Subject: Lot 3, Timber
Grove Estates.

SUBJECT: Proposed Amendment to Parcel 1 of the Timber Grove Lakes CUP (DP-134) generally located northwest of the intersection of Central and Maize Road.

CASE NUMBER: S/D 94-28 TIMBER GROVE LAKES 2ND ADDITION

CASE NUMBER: S/D 94-37 TIMBER GROVE LAKES COMMERCIAL ADDITION

STAFF REPORT
(Preliminary Plat)

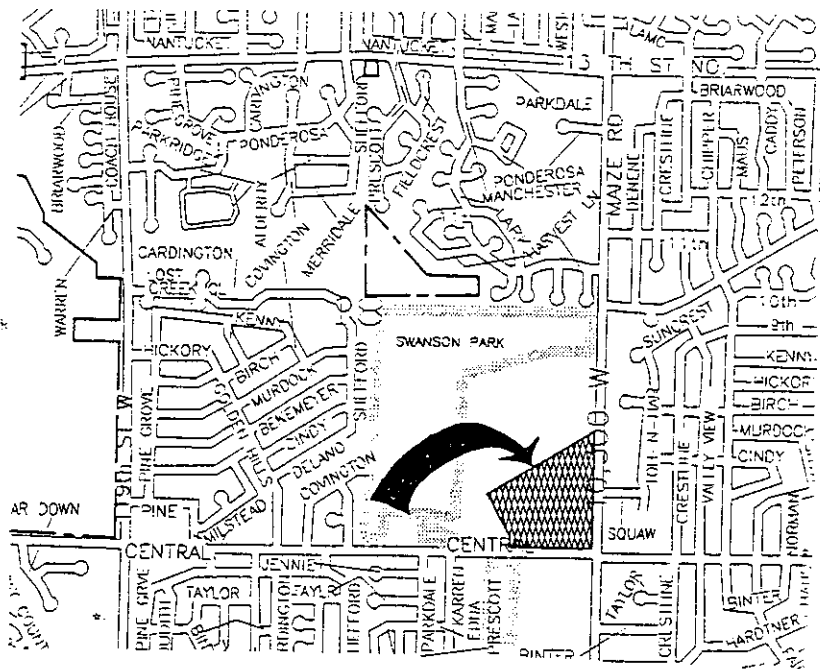
- A. Approval of this plat shall be subject to approval of the Zone Change (Z-3126) and the amended CUP. The plat shall also reflect any conditions or requirements of the zone change and/or CUP approvals.

- B. The applicant shall guarantee the extension of sanitary sewer to serve the lots being platted. This guarantee shall also provide for any abandonment, termination, etc. of existing sewer lines made necessary by this replat. Also, a major sewer line is apparently located quite close to the south line of this plat and Engineering needs to indicate if an easement should be platted in this area.

- C. The applicant shall guarantee any drainage improvements required by the platting of this property.
- D. City Engineering needs to indicate the status of existing petitions for this site and whether any projects are effected by this plat and consequently if any costs are involved due to abandoning or amending these projects.

- E. Traffic Engineering also needs to indicate any requirements for providing new or altering existing traffic improvements to serve this site. Specifically, major entrances on Central and Maize are being relocated from what was previously expected and zoning and uses per the CUP are being significantly altered.

- H. Since several lots will not have direct access to Central or Maize, a joint access easement shall be submitted for recording with the plat which indicates that these lots are to be allowed access across Lot 1 and/or the other lots in order to use the major entrances or other access openings to Central and Maize.

- I. On the final plat, Lot 4 shall from the intersection of Central and Maize show 100-feet of complete access control to Central and complete access control to Maize Road for the area south of the existing, southern most drive.

- J. A note shall be placed on the face of the plat indicating that Additional Building Setbacks are per the Community Unit Plan (how ever the CUP is officially designated following City Council approval, e.g. DP-134 Amendment #2).

- K. As indicated by the original plat of this site, a minimum building pad elevation shall be provided. Both the face of the plat and the plattor's text shall indicate this elevation, noting also whether the elevation is for the lowest opening or floor level. Both on-site and off-site benchmarks shall be referenced.

- N. The applicant is advised that at the time the 1st Addition was platted various private and/or emergency access easements may have been created that effected this site. If any such easements are noted in the platting binder, such easements must be shown on the final plat and cannot be vacated by this revised plat. Any such private easements must be released by the parties benefitting.

- Q. Prior to or at the time of submitting the final plat, the applicant shall submit a drainage plan to City Engineering for review and approval.
- R. The applicant's engineer is advised that the Register of Deeds is requiring the name(s) of the notary public, who acknowledges the signatures on this plat, to be printed beneath the notary's signature.

STAFF REPORT
(Final Plat)

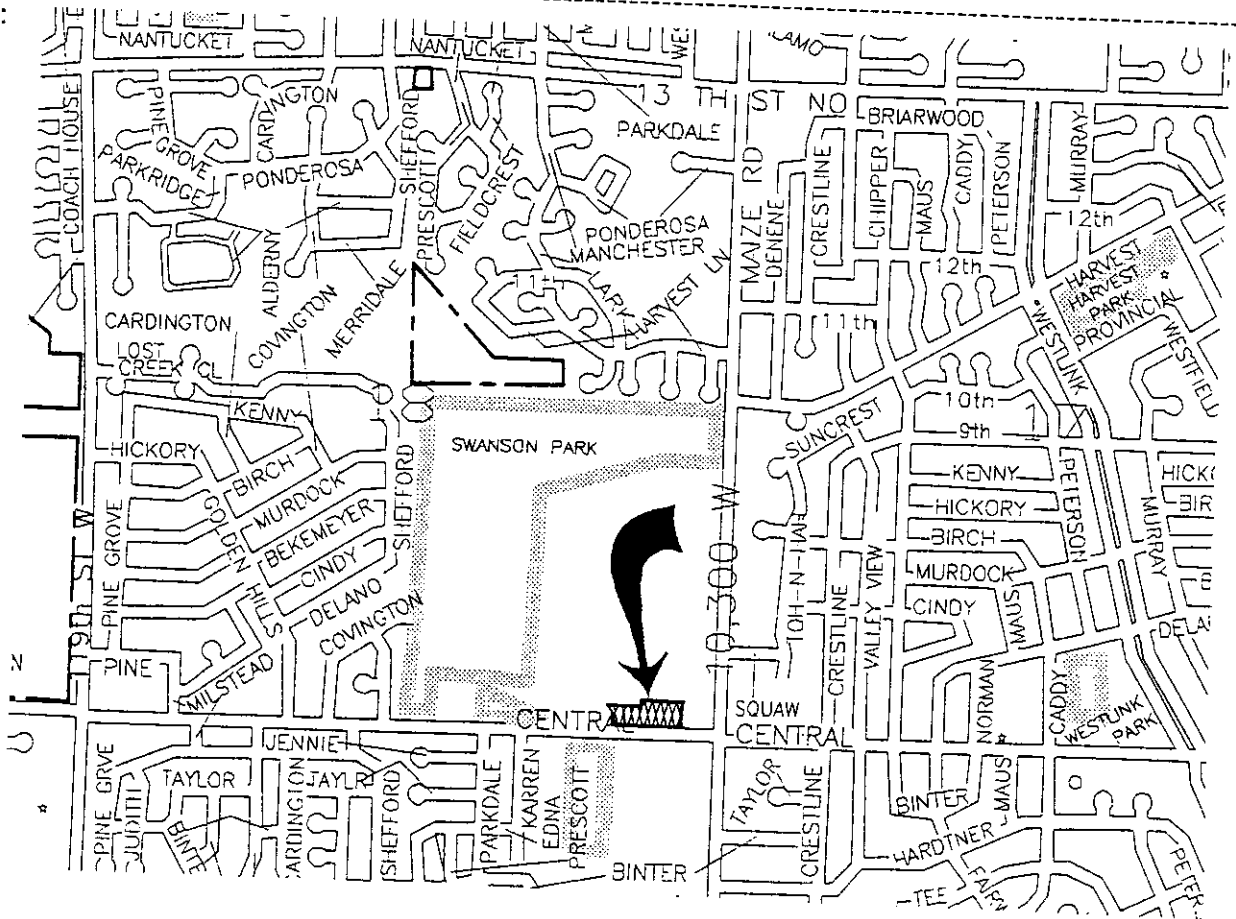
- A. Prior to this plat being forwarded to the City Council for approval, the applicant shall obtain the needed amendments or adjustments needed for this plat. Specifically, the relocation of a major entrance from Central and reductions in required building setbacks to Central need to be obtained.

- B. City Engineering needs to indicate if the lots being platted have acceptable access to sanitary sewer or if extensions need to be guaranteed.
- C. The applicant shall guarantee any drainage improvements required by the platting of this property.

- G. Since this plat is indicating that the ownership and maintenance of Reserve A is being assumed by a property not included within the area being platted, a legal opinion shall be submitted indicating that such an assignment of responsibility can be indicated as shown on this plat. However, the applicant shall also submit proof of ownership of the property being made responsible for Reserve A and a covenant for recording with this plat indicating such responsibilities and that the terms of the covenant run with the land and are binding on future owners and assigns.

- H. Since Lot 1 does not have direct access to a public street, but rather is intended to have access through Reserve A, the above noted covenant shall also specifically establish Lot 2's right of access to Reserve A and any related rights or responsibilities for the use of Reserve A.

- I. A note shall be placed on the face of the final plat tracing indicating that this plat is subject to the conditions of a CUP (DP-134 as amended) and may be subject to additional setback requirements per the CUP.

- J. When the preliminary plat was reviewed, both City Engineering and the Utilities requested a number of easements on this site. None of these easements have, however, been shown.

Unless indicated otherwise, the final plat tracing shall indicate a 10-foot easement along the plat's south line and 15-foot easements along the north line of Lots 1 & 2.

- K. Unless indicated otherwise, the final plat tracing shall note that the minimum building pad elevations are for the lowest floor. During review of the preliminary plat, City Engineering indicated the lowest floor as the requirement.
